## A NEW SEALANT

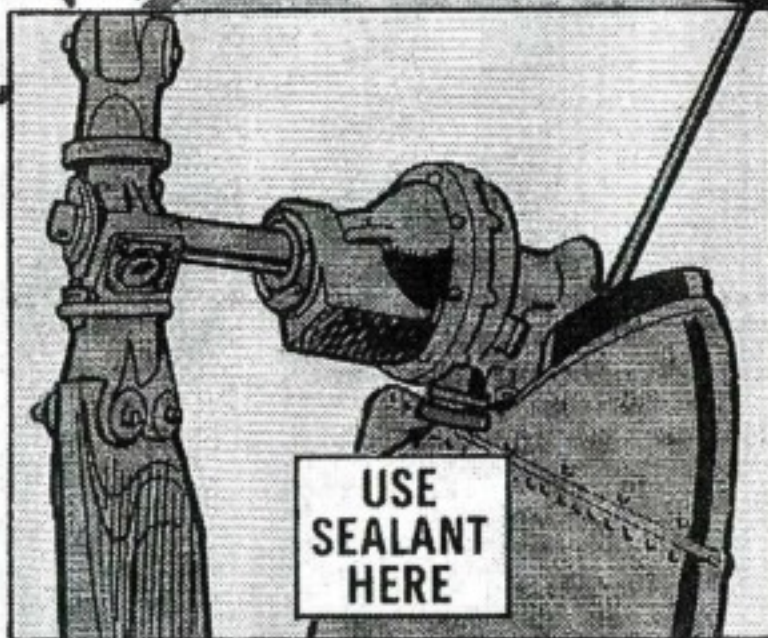
Hueys coming off the production line now have Sealing Compound, MIL-S-8802, applied around the edge of the 90° gear box. It does a good job of keeping moisture from getting in between the gear box and mount.

The pubs are being updated to require use of the sealant, after mounting the gear box. NSN 8030-00-753-5006 will get you a 2½-oz tube of sealant, item 207, Table 1-2 of TM 55-
